MEMO

Department of Water Resources

Date: March 2, 2009

Subject: Application for Water Right 63-32573

Figure 2. Mapped faults on and near the M3 property (Reproduced from Wood, 2007).

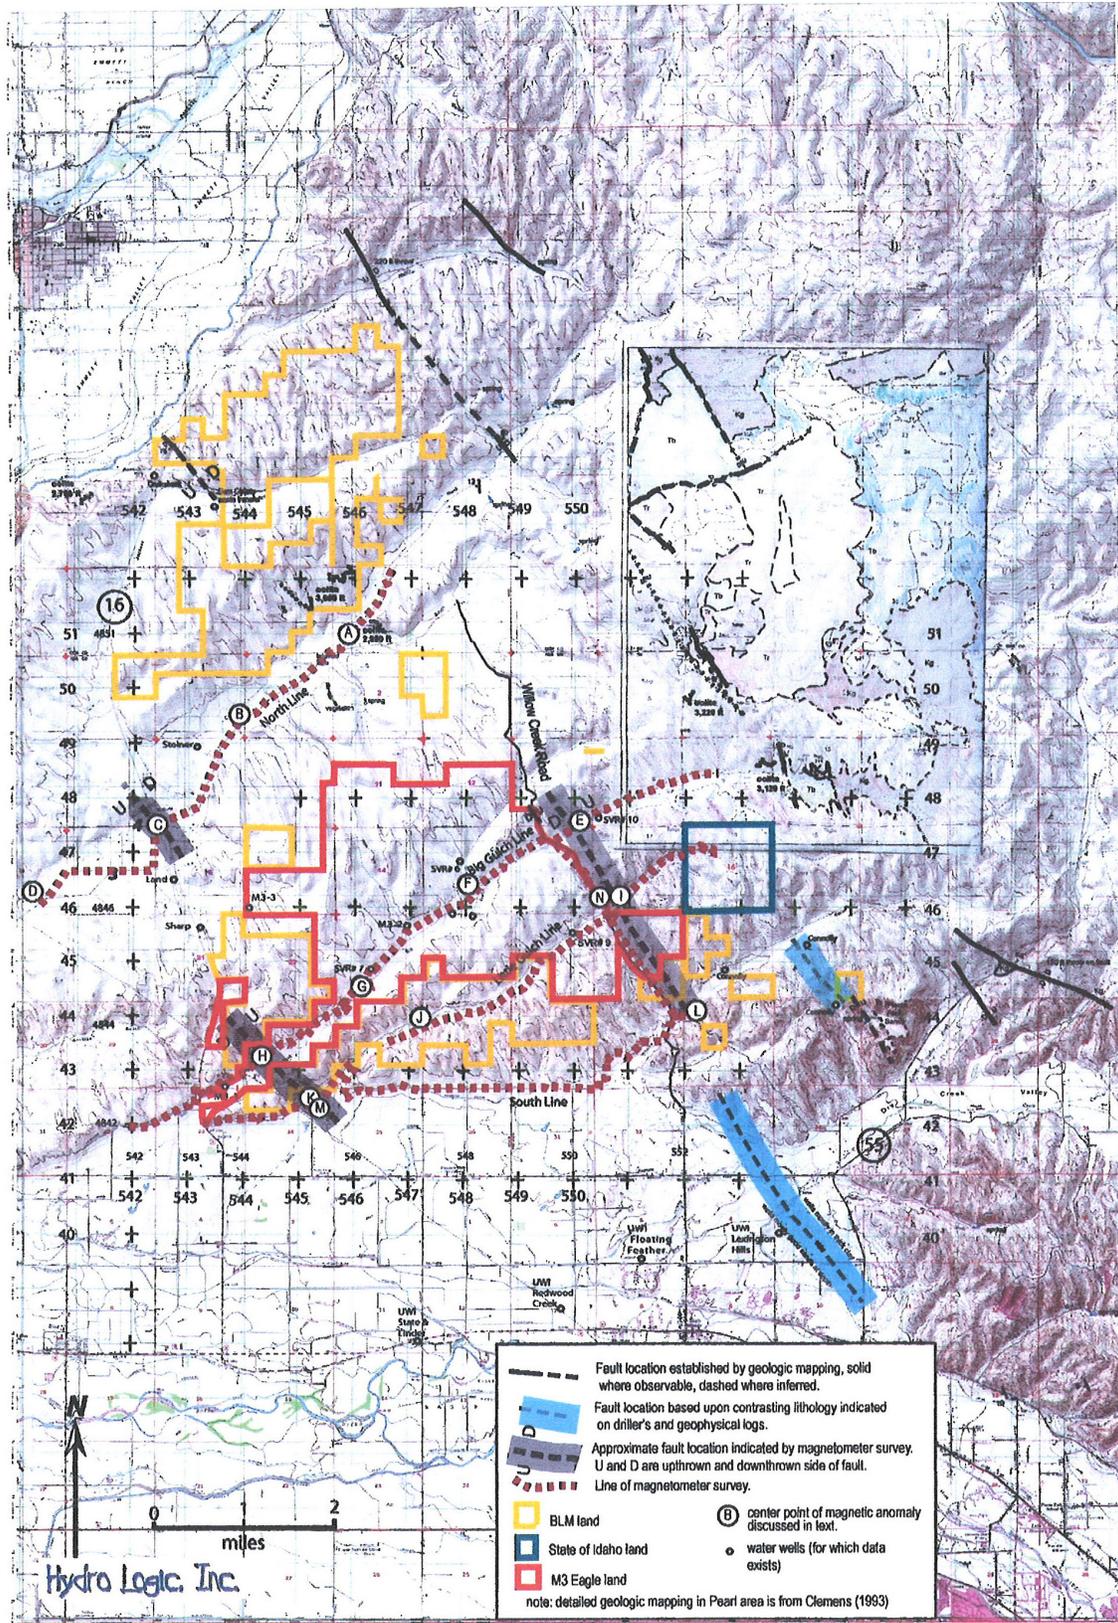
The magnetometer survey was conducted by BSU in 2006, with the results interpreted by Dr. Spence Wood. Wood identified two NW/SE trending “major” faults that transect the M3 property (Figure 2) and determined that sediments beneath M3 extend to a depth of more than 3,000 ft (Wood, 2007). Wood also identified several other off-site faults with the same NW/SE orientation.

- The cross-section that bisects Big Gulch does not show the fault between TW#1 and TW#4 that was identified in surface geophysical work contracted by HLI (Wood, 2007). The offset from this fault could account for, at least in part, some of the differences in elevation of the tops and bottoms of the various strata that are represented as uninterrupted. The identification of faults is important for the characterization of the hydrogeology because faults often affect hydraulic communication between hydrostratigraphic units.

- The NW/SE trending normal fault identified by Wood (2007) separates the two well groups and potentially accounts for the different water level fluctuation patterns.

Figure 3. Predicted drawdowns using image well analysis after 50 years of pumping at 10 cfs from the PGSA beneath M3 property.

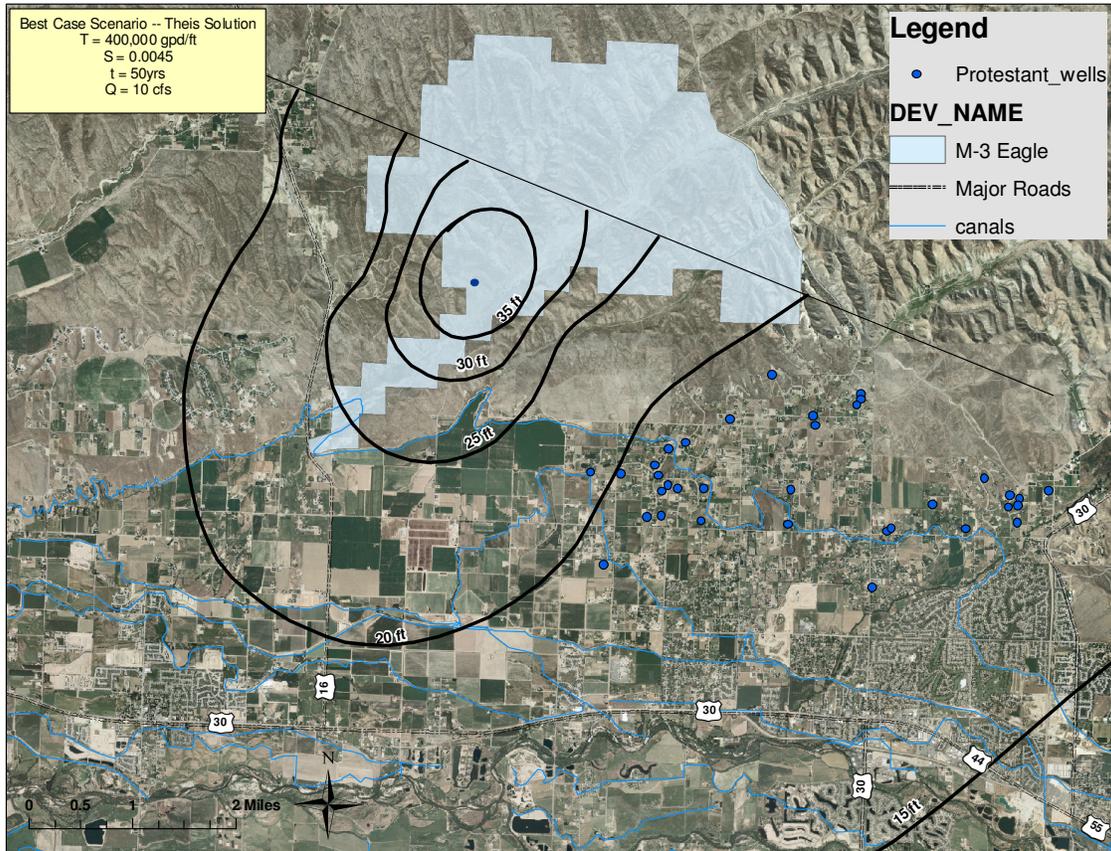
Approximately two miles south of the M3 property, at the intersection of Floating Feather Road and Highway 16, the image well analysis predicted drawdowns of approximately four feet for the best case and eight feet for the worst case (see Figures 9 and 10 in HLI, 2007a). Using the same general methodology but substituting aquifer properties from HLI’s SVR#7 aquifer test (transmissivity = 400,000 gpd/ft, storage = 0.0045), IDWR staff calculated drawdown for a revised pumping rate of 4,500 gpm and a pumping period of 50-years (the same time-frame evaluated with the M3 model). Our calculation is conservative in the sense that it neglects to consider recharge but not-conservative because it assumes that the aquifer extends infinitely in the southwest (down-dip) direction. The predicted drawdown at the intersection of Floating Feather Road and Highway 16 is approximately 18 feet after 50 years of pumping (Figure 3).

It is common practice to predict long-term aquifer performance using time-frames that are less than 50 years when applying analytical methods which are based on the Theis (1935) nonequilibrium solution. The Idaho Department of Environmental Quality, for example, recommends that a one-year time-frame be used to project long-term drawdown for public water supply wells. The use of a shorter time-frame can be appropriate, in part because the Theis (1935) solution is premised on the assumption that there are no sources of recharge. With all other input unchanged, application of the image well analysis using a pumping period of one year instead of 50 years results in a similar water level drawdown pattern but the drawdowns are of lower magnitude. The calculated drawdown after one year of pumping at 10 cfs is approximately 8 feet at the intersection of Floating Feather Road and Highway 16.

Figure 4. Map showing the results of predicted drawdown from the Hmatch version of the M3 ground water flow model (HLI, 2008a, Appendix B, Figure 14).

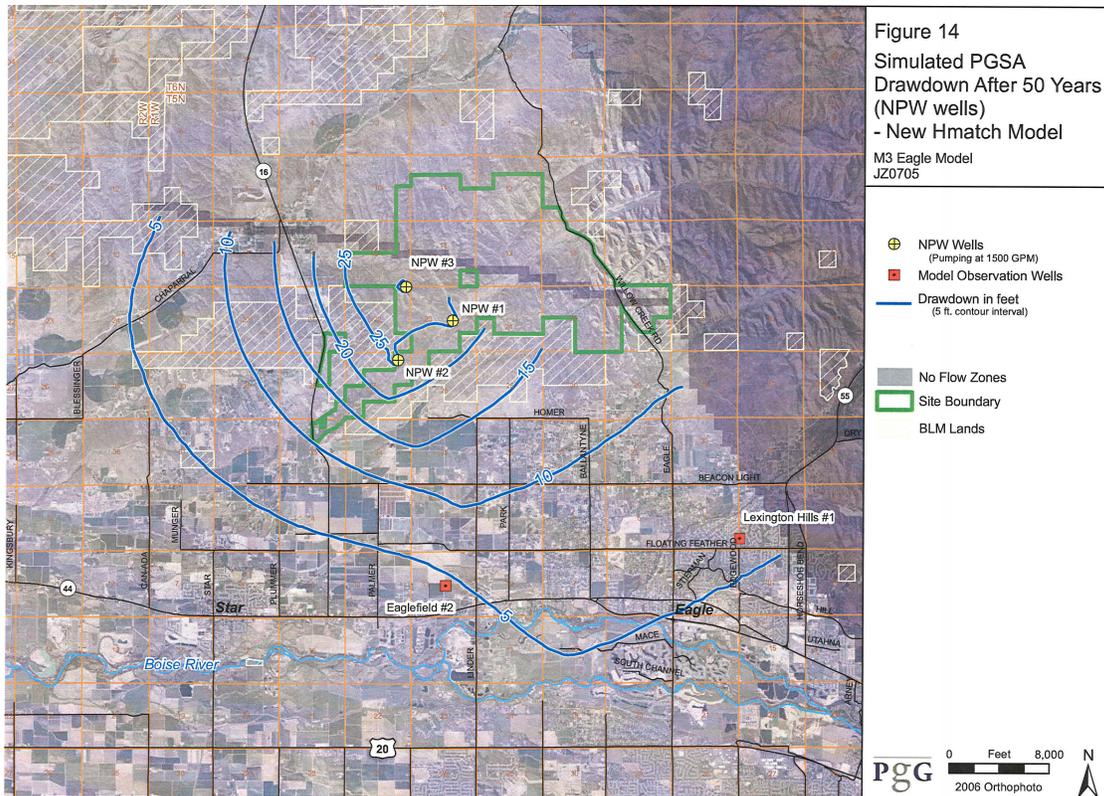
As previously discussed, HLI contracted the development of a ground water flow model that was used to predict impacts from the pumping of high capacity wells on the M3 property. The “Hmatch” version of the model indicates that 50 years of pumping three wells at a combined total rate of 10 cfs will cause drawdown in the PGSA that ranges from approximately 30 feet on the property to around five feet at the intersection of Floating Feather Road and Highway 16 near Eagle (Figure 4).

The NW/SE trending fault identified between TW#4 and TW#1 through magnetometer studies was not included in any of the impact assessments performed by HLI or the Department. Based on HLI’s aquifer test analysis, this fault potentially represents a no-flow boundary, which could significantly alter the predictions by causing more drawdown on the pumping side of the fault and less drawdown on the non-pumping side.
